DESKTOP GEOTECHNICAL ASSESSMENT FOR PREFEASIBILITY STUDY

Blacksmith Lease, Pilbara Iron Ore Project

Report Number. 097641461-034-R-Rev0

Figure 5: Ajax Pits, highlighting areas of geotechnical risk (refer to Table 1)

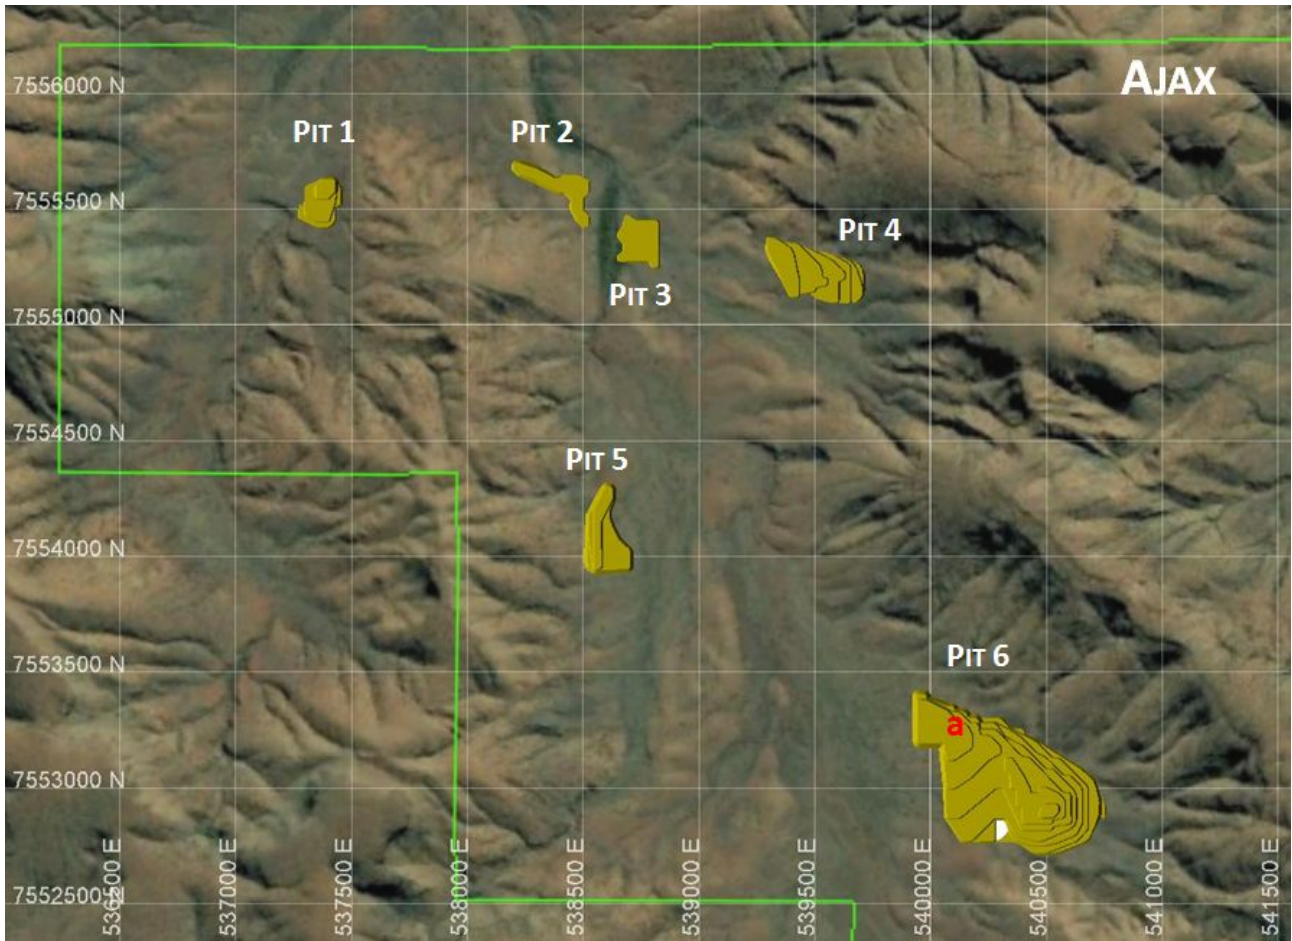
Area	Description	Geotechnical Risk	Risk Management
a	17 m (vertical height) undulating slope at a 45 degree angle striking for 170 m	Instability caused by the convex shape of the slope	Change design – straighten slope or make slightly concave
	natural slope at 12 degrees immediately north-east of the pit, large catchment	potential flooding

Figure 6: Ajax Pits, highlighting areas of geotechnical risk (refer to Table 2, Table 3 and Table 4)

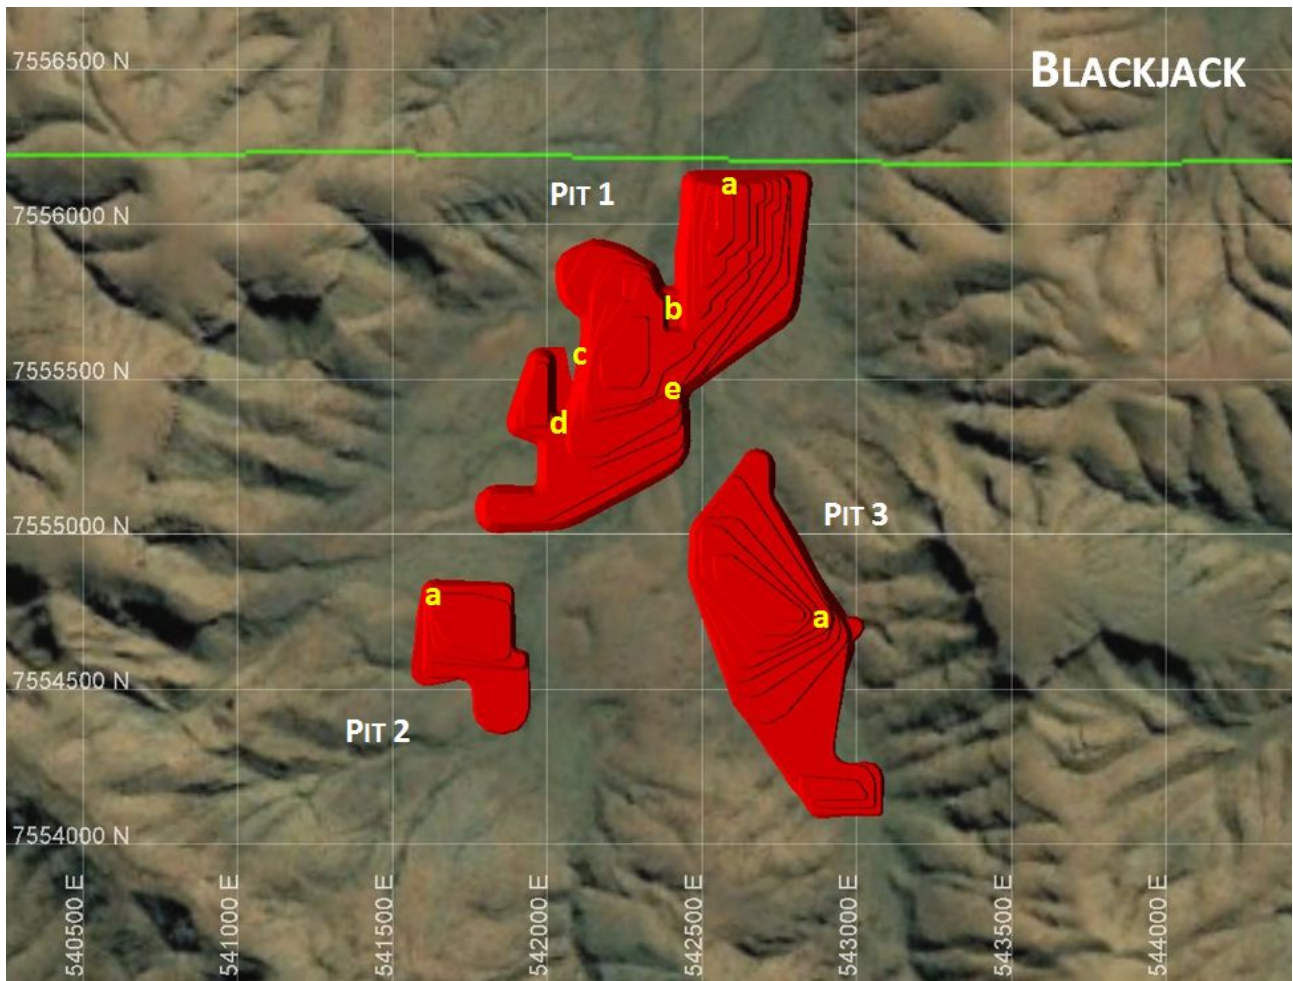
Area	Description	Geotechnical Risk	Risk Management
a	52 m (vertical height) slope at 45 degrees with no benches. Crest is 30 m from lease boundary	Instability could pose risk to equipment/personnel below	Either step in a bench or flatten slope angle
b	42 m (vertical height) slope at 45 degrees flanking a bullnose. The front of the bullnose is stepped with benches of 16 m (max. vertical height) and berm widths of 30 m (minimum).	Instability could pose risk to equipment/personnel below	Remove or reduce bullnose
c	47 m (vertical height) slope at 45 degrees with no benches	Instability could pose risk to equipment/personnel below	Either step in a bench or flatten slope angle
d	24 m (vertical height) bullnose at a 45 degree slope angle	Instability caused by the convex shape of the slope	Either step in a bench or flatten slope angle
e	40 m (vertical height) convex slope at a 45 degree angle	Instability caused by the convex shape of the slope	Either step in a bench or flatten slope angle

Area	Description	Geotechnical Risk	Risk Management
a	23 m (vertical height) slope at a 45 degree angle in the north-west corner of the pit	Instability could pose risk to equipment/personnel below	Either step in a bench or flatten slope angle

Area	Description	Geotechnical Risk	Risk Management
a	40 m (vertical height) slope at a 45 degree angle	Instability could pose risk to equipment/personnel below	Either step in a bench or flatten slope angle

Figure 7: Champion Pits, highlighting areas of geotechnical risk (refer to Table 5, Table 6, Table 7, Table 8, Table 9, Table 10 and Table 11)

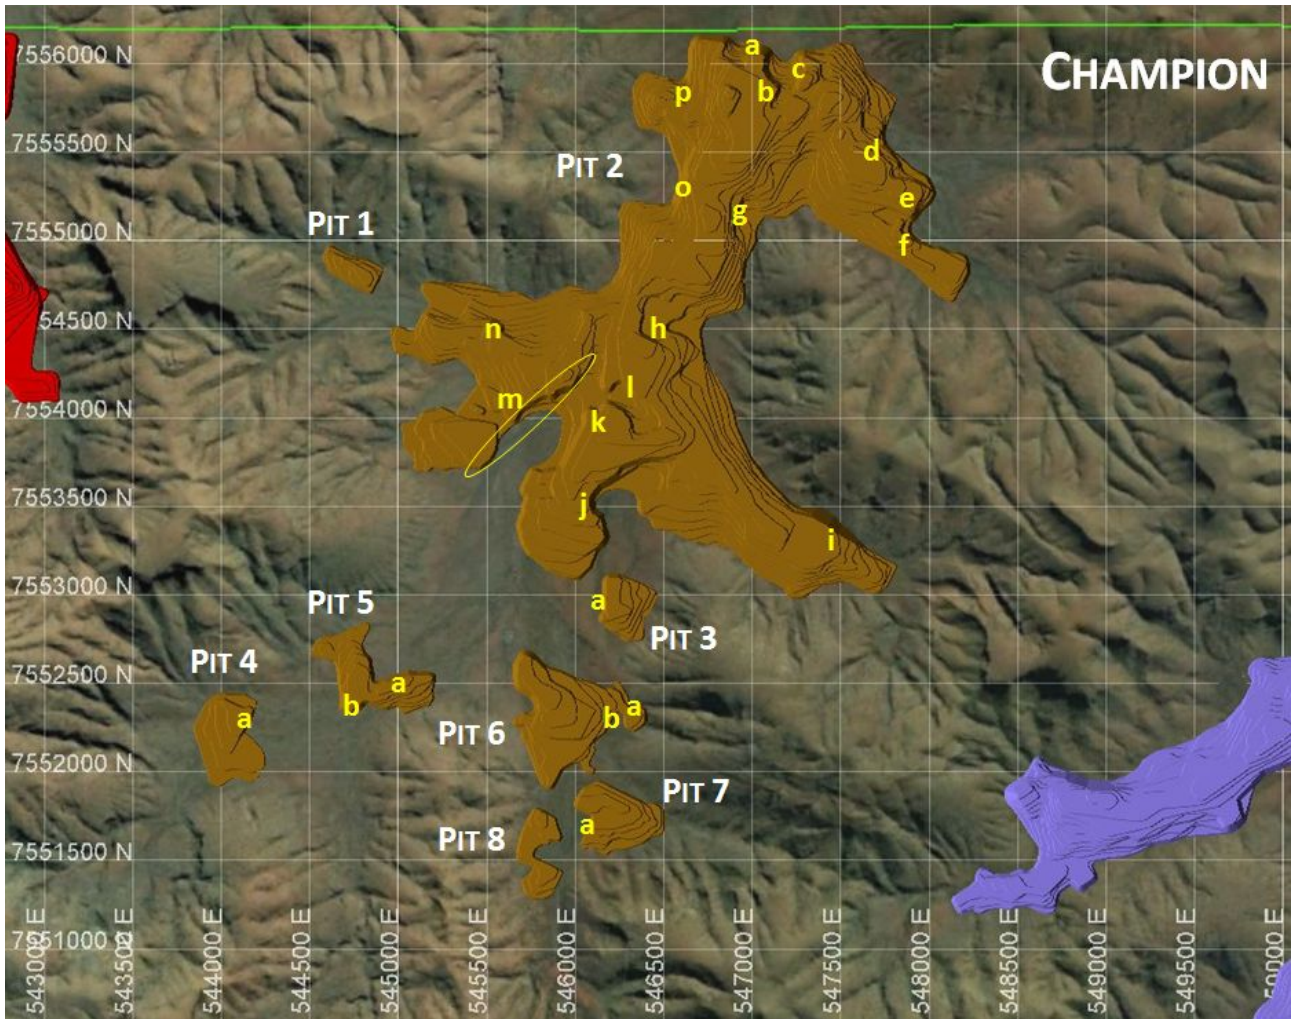
Area	Description	Geotechnical Risk	Risk Management
a	22 m (vertical height) slope at a 45 degree angle	Instability could pose risk to equipment/personnel below	Either step in a bench or flatten slope angle

Area	Description	Geotechnical Risk	Risk Management
a	57 m (vertical height) concave slope at a 45 degree angle	Instability could pose risk to equipment/personnel below	Either step in a bench or flatten slope angle
b	36 m (vertical height) convex slope at a 45 degree angle	Instability caused by the convex shape of the slope	Either step in a bench or flatten slope angle
c	36 m (vertical height) slope at a 45 degree angle	Instability could pose risk to equipment/personnel below	Either step in a bench or flatten slope angle
d	Two 18 m (vertical height) slightly convex slopes at 45 degree angles	Instability caused by the convex shape of the slope	Acceptance of risk? And procedural management
e	45 m (vertical height) slope at a 45 degree angle	Instability could pose risk to equipment/personnel below	Either step in a bench or flatten slope angle
f	18 m (vertical height) convex slope at a 45 degree angle	Instability caused by the convex shape of the slope	Acceptance of risk? And procedural management

g	24 m (vertical height) slightly convex slope at a 45 degree angle	Instability caused by the convex shape of the slope	Either step in a bench or flatten slope angle, Acceptance of risk and procedural management?
h	18 m (vertical height) convex slope at a 45 degree angle	Instability caused by the convex shape of the slope	Acceptance of risk? And procedural management
i	72 m (vertical height) slope at a 45 degree angle with a natural slope at a 20 degree angle above it	Instability could pose risk to equipment/personnel below	Either step in a bench or flatten slope angle
j	42 m (vertical height) convex slope at a 45 degree angle	Instability caused by the convex shape of the slope	Either step in a bench or flatten slope angle
k	24 m (vertical height) convex slope at a 45 degree angle	Instability caused by the convex shape of the slope	Either step in a bench or flatten slope angle, acceptance of risk? And procedural management

l	24 m (vertical height) convex slope at a 45 degree angle	Instability caused by the convex shape of the slope	Either step in a bench or flatten slope angle, acceptance of risk? And procedural management
m	36 m (vertical height) undulating slope at a 45 degree angle striking for 440 m	Instability caused by the convex shape of the slope	Change design – straighten slope or make slightly concave. Drilling may be required
n	36 m (vertical height) slope at a 45 degree angle	Instability could pose risk to equipment/personnel below	Either step in a bench or flatten slope angle
o	54 m (vertical height) slightly convex slope at a 45 degree angle	Instability caused by the convex shape of the slope	Either step in a bench or flatten slope angle
p	18 m (vertical height) convex slope at a 45 degree angle	Instability caused by the convex shape of the slope	Either step in a bench or flatten slope angle, acceptance of risk? And procedural management

Area	Description	Geotechnical Risk	Risk Management
a	27 m (vertical height) slope at a 45 degree angle	Instability could pose risk to equipment/personnel below	Either step in a bench or flatten slope angle

Area	Description	Geotechnical Risk	Risk Management
a	22 m (vertical height) slope at a 45 degree angle	Instability could pose risk to equipment/personnel below	Either step in a bench or flatten slope angle, acceptance of risk? And procedural management

Area	Description	Geotechnical Risk	Risk Management
a	31 m (vertical height) slope at a 45 degree angle	Instability could pose risk to equipment/personnel below	Either step in a bench or flatten slope angle
b	28 m (vertical height) convex slope at a 45 degree angle

Area	Description	Geotechnical Risk	Risk Management
a	21 m (vertical height) convex slope at a 45 degree angle	Instability caused by the convex shape of the slope	Either step in a bench or flatten slope angle, acceptance of risk? And procedural management
b	12 m (vertical height) convex slope at a 45 degree angle	Instability caused by the convex shape of the slope	Acceptance of risk? And procedural management

Area	Description	Geotechnical Risk	Risk Management
a	18 m (vertical height) convex slope at a 45 degree angle	Instability caused by the convex shape of the slope	Acceptance of risk? And procedural management

Figure 9: Delta Pit, highlighting areas of geotechnical risk (refer to Table 14)

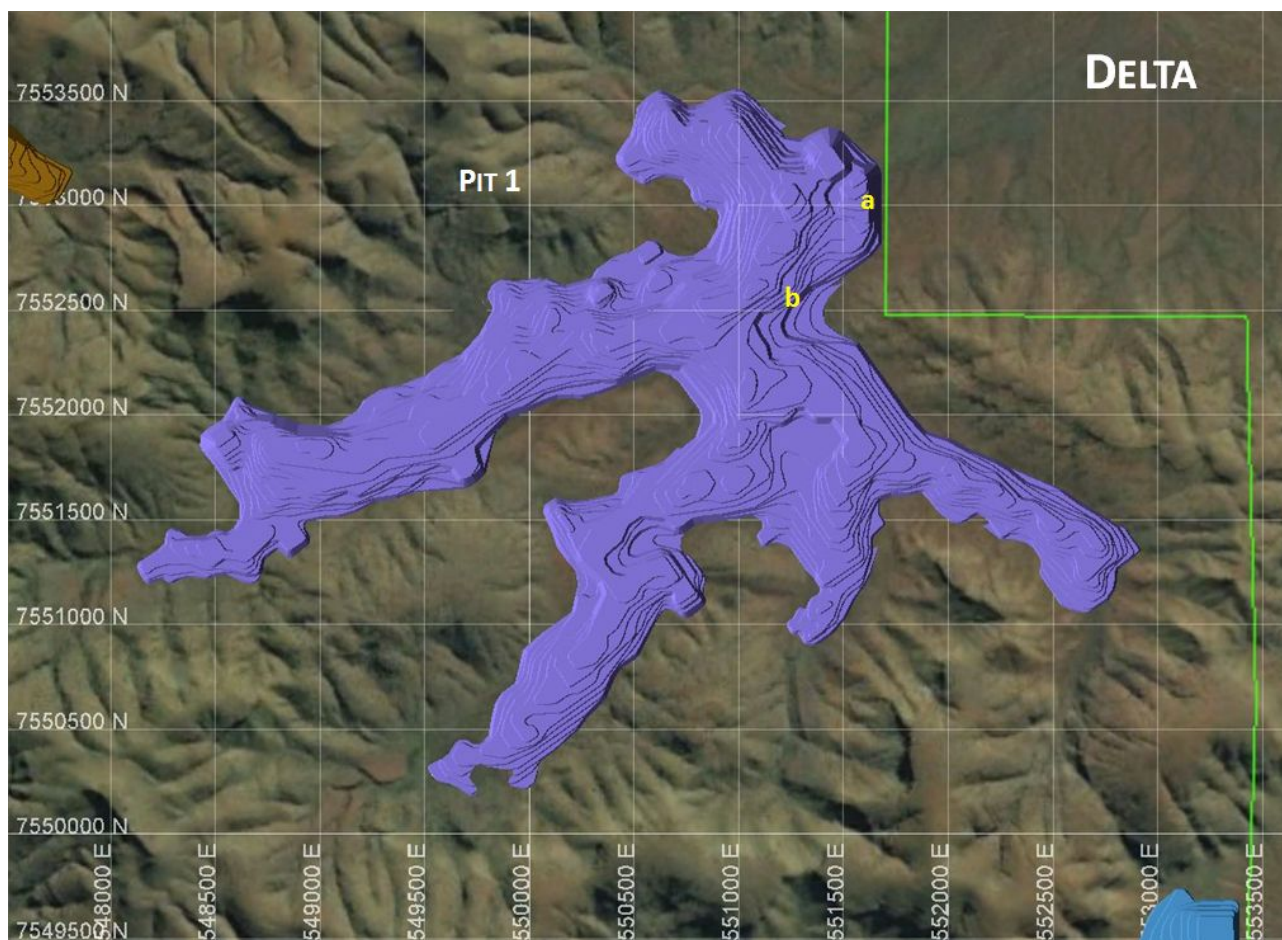
Area	Description	Geotechnical Risk	Risk Management
a	75 m (vertical height) slope at a 45 degree angle	Instability could pose risk to equipment/personnel below	Either step in a bench or flatten slope angle
b	30 m (vertical height) slightly convex slope at a 45 degree angle	Instability could pose risk to equipment/personnel below	Either step in a bench or flatten slope angle

Figure 10: Badger Pits, highlighting areas of geotechnical risk (refer to Table 15 and Table 16)

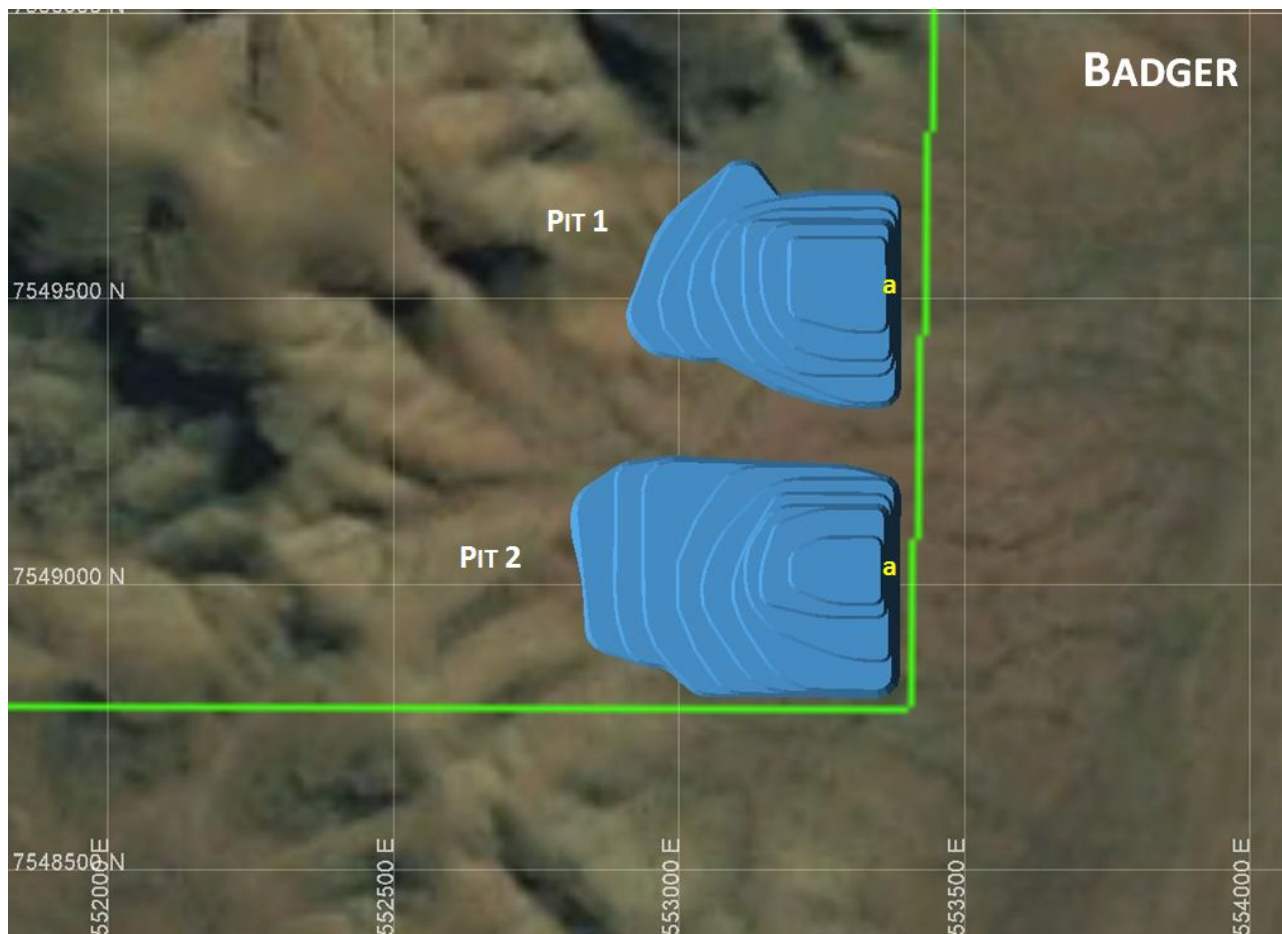
Area	Description	Geotechnical Risk	Risk Management
a	27 m (vertical height) slope at a 45 degree angle with the crest 31 m from the lease boundary	Instability could pose risk to equipment/personnel below	Either step in a bench or flatten slope angle

Area	Description	Geotechnical Risk	Risk Management
a	34 m (vertical height) slope at a 45 degree angle with the crest 20 m from the lease boundary	Instability could pose risk to equipment/personnel below	Either step in a bench or flatten slope angle
	Southern edge of pit 20 m from lease boundary

Figure 11: Eagle Pits, highlighting areas of geotechnical risk (refer to Table 17, Table 18, Table 19, Table 20 and Table 21)

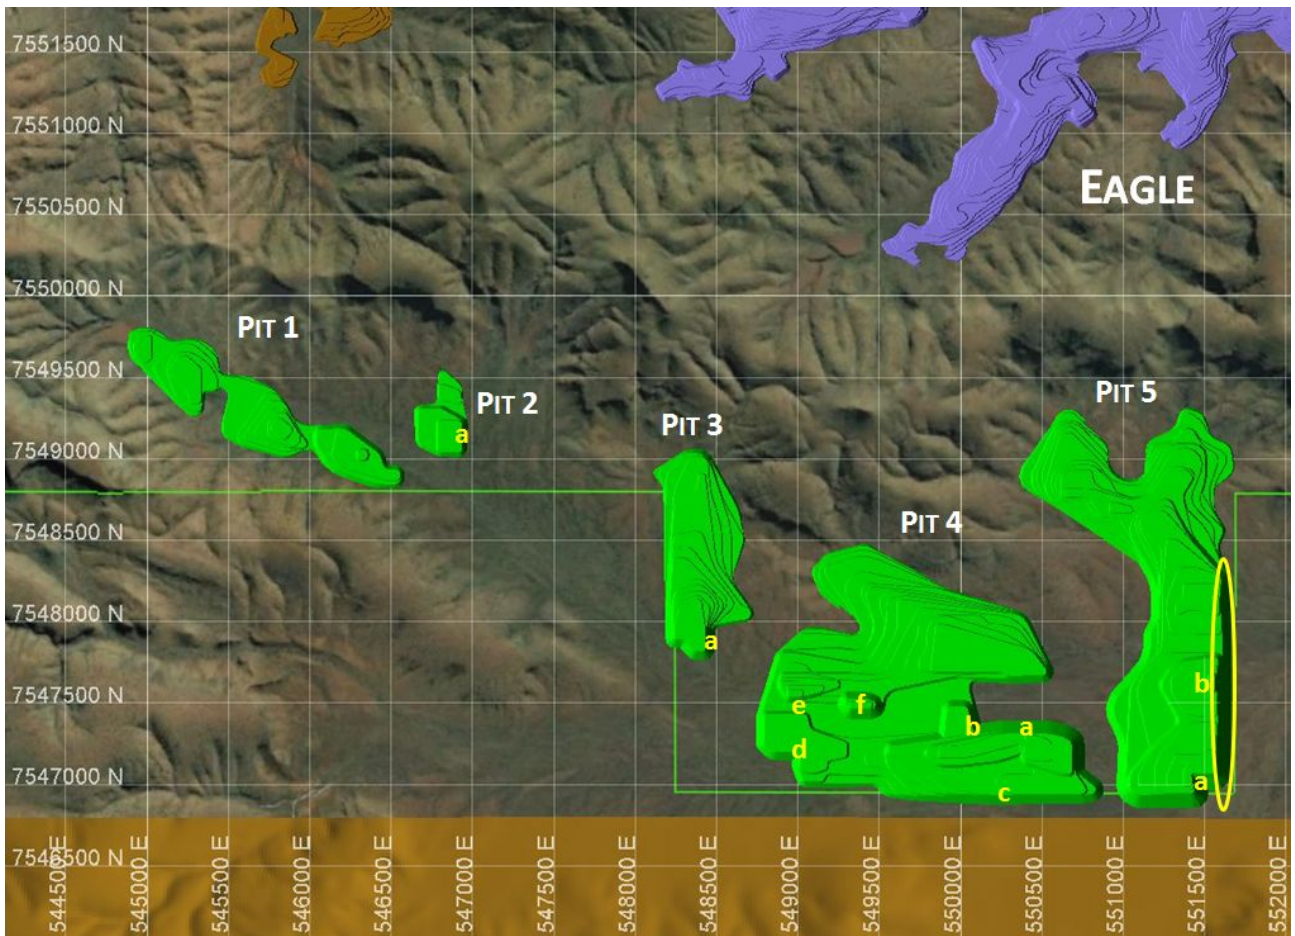
Area	Description	Geotechnical Risk	Risk Management
	Southern edge of pit is 20 m from lease boundary

Area	Description	Geotechnical Risk	Risk Management
a	32 m (vertical height) slope at a 45 degree angle	Instability could pose risk to equipment/personnel below	Either step in a bench or flatten slope angle

Area	Description	Geotechnical Risk	Risk Management
a	57 m (vertical height) slope at a 45 degree angle	Instability could pose risk to equipment/personnel below	Either step in a bench or flatten slope angle
	Western edge of pit approximately 56 m outside of lease area

Area	Description	Geotechnical Risk	Risk Management
a	88 m (vertical height) slope at a 45 degree angle	Instability could pose risk to equipment/personnel below	Either step in a bench or flatten slope angle
b	55 m (vertical height) convex slope (bullnose) at a 45 degree angle	Instability caused by the convex shape of the slope	Either step in a bench or flatten slope angle
c	65 m (vertical height) slope at a 45 degree angle	Instability could pose risk to equipment/personnel below	Either step in a bench or flatten slope angle
d	48 m (vertical height) convex slope (bullnose) at a 45 degree angle	Instability caused by the convex shape of the slope	Either step in a bench or flatten slope angle
e	40 m (vertical height) slope at a 45 degree angle	Instability could pose risk to equipment/personnel below	Either step in a bench or flatten slope angle
f	65 m (vertical height) slope at a 45 degree angle	Instability could pose risk to equipment/personnel below	Either step in a bench or flatten slope angle

Southern edge of pit is 60 m outside lease boundary

Area	Description	Geotechnical Risk	Risk Management
a	100 m (vertical height) convex slope (bullnose) at a 45 degree angle	Instability caused by the convex shape of the slope	Either step in a bench or flatten slope angle
b	60-90 m (vertical height) slope at a 45 degree angle striking for 1.2 km along the eastern margin of the pit	Instability caused by the convex shape of the slope	Change design – straighten slope or make slightly concave. Drilling may be required
	Southern edge of pit is 90 m outside lease boundary		
	Eastern edge of pit is 16 m from lease boundary
